NOTICE TO CONTRACTORS BIDDING THIS PROJECT

Project Title: Building and Site Improvements at 6741 Downing Avenue, Bakersfield, CA

Contract No: 26016

ADDENDUM No. 5

3

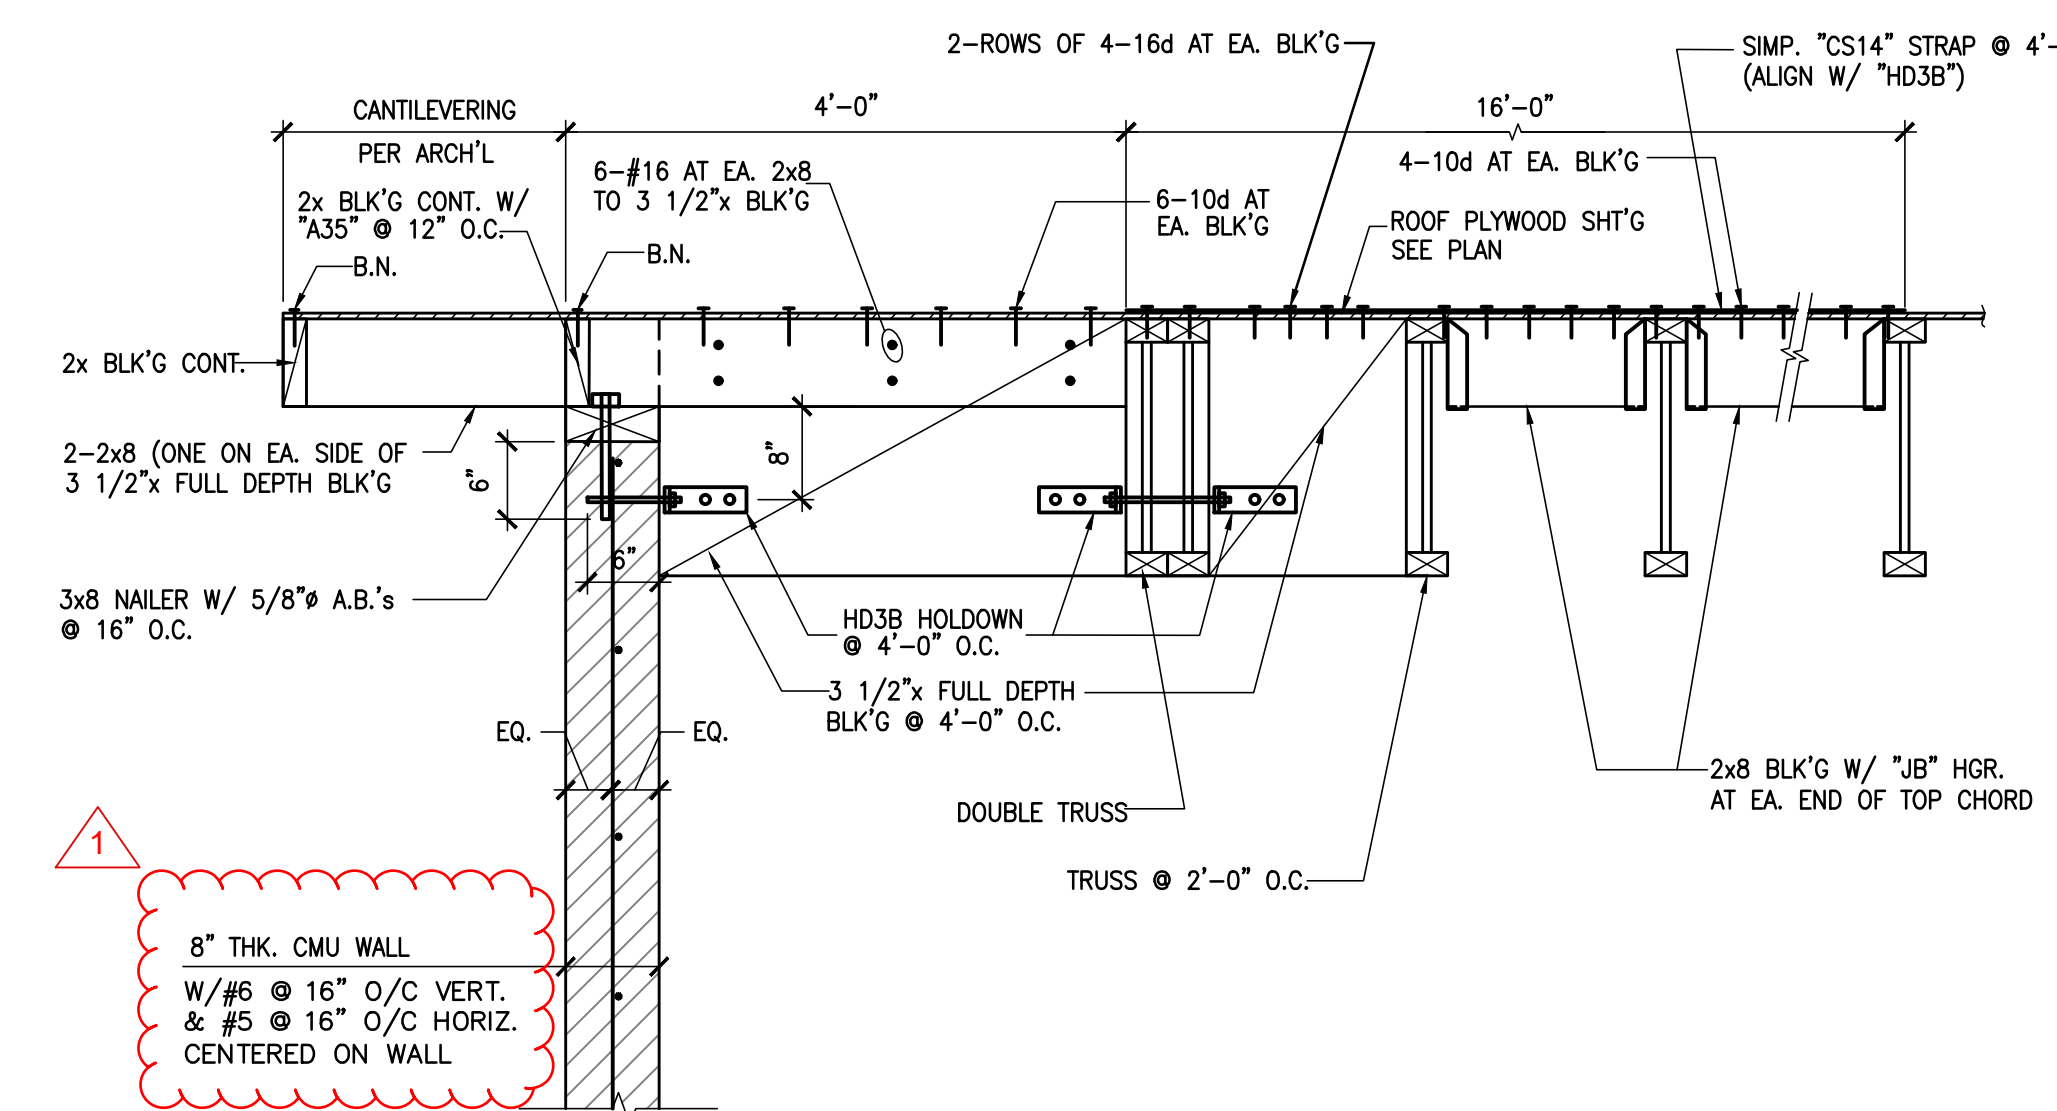
- n. Sheet AD2 has been replaced with sheet AD2A. Detail 28/AD2A has been provided to clarify bike rack requirements. The revised sheet is attached to this addendum.

JOB	
DP	
PM	E002A

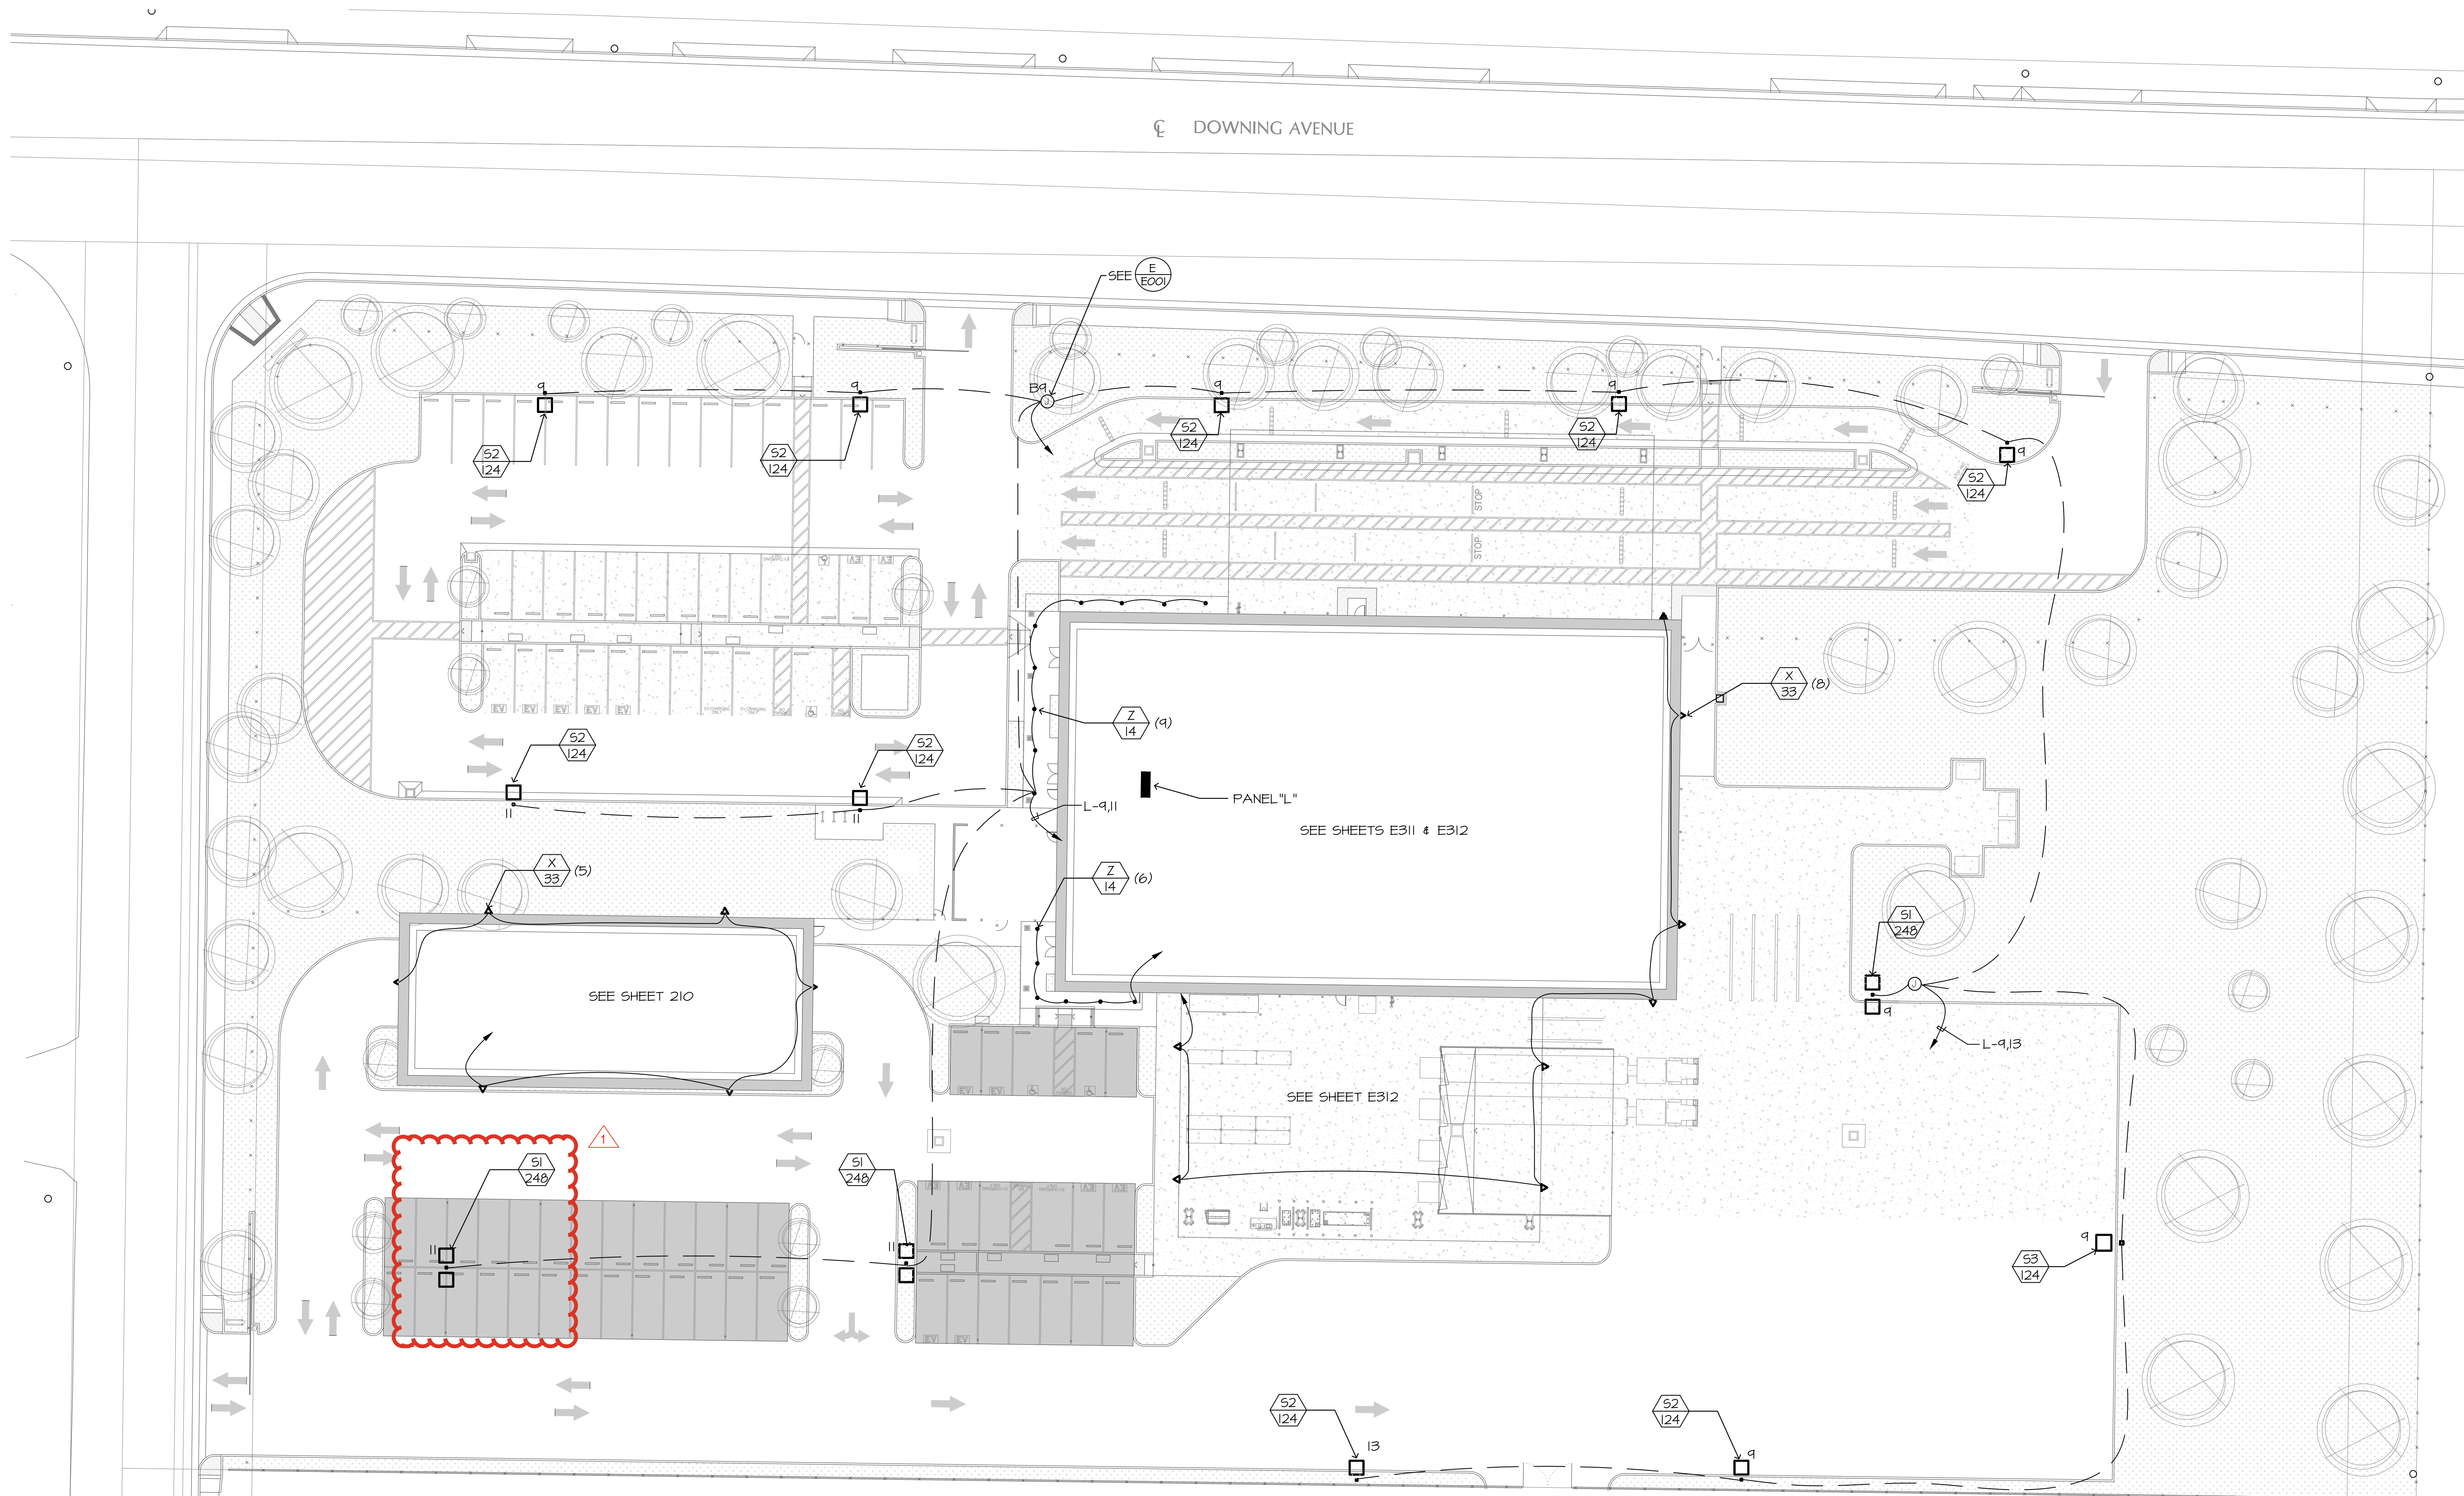
- q. Sheet E002 has been replaced with sheet E002A. Additional light fixtures have been added to light fixture schedule. The revised sheet is attached to this addendum.

JOB	
DP	E212A
PM

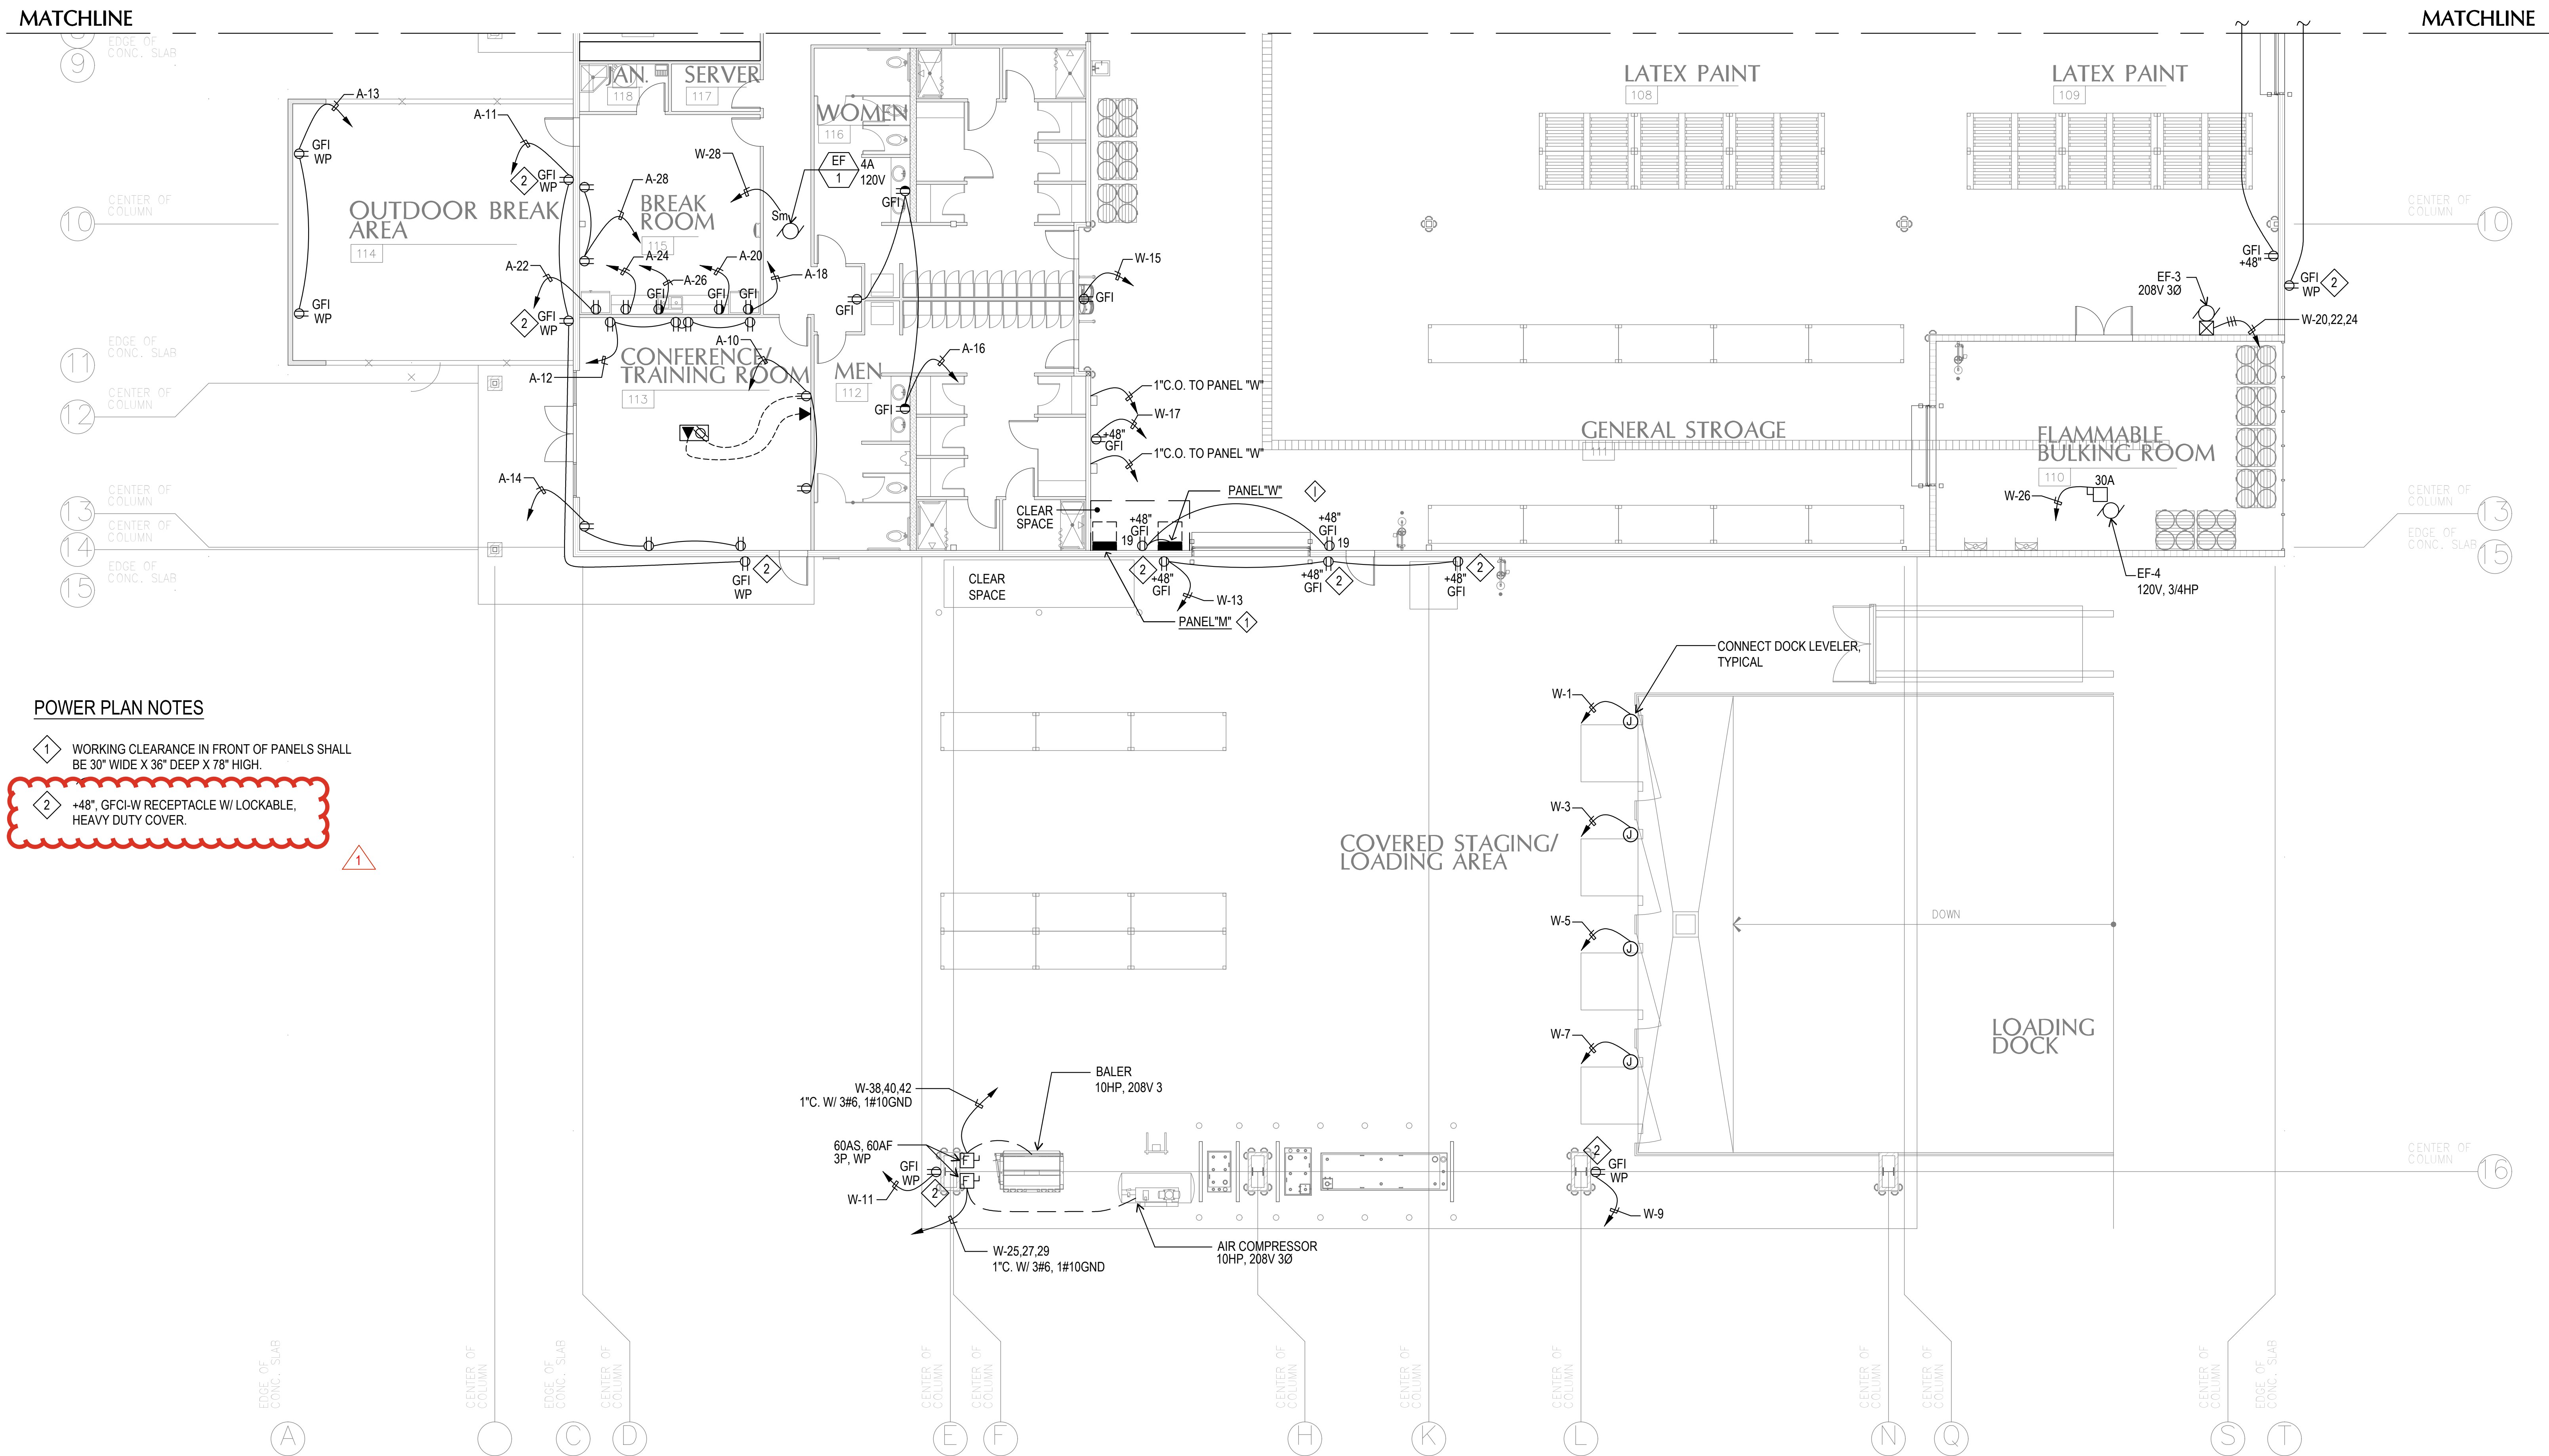
- t. Sheets E211 and E212 have been replaced with sheets E211A and E212A. Installation height of exterior GFCI outlets has been added. The revised sheet is attached to this addendum.
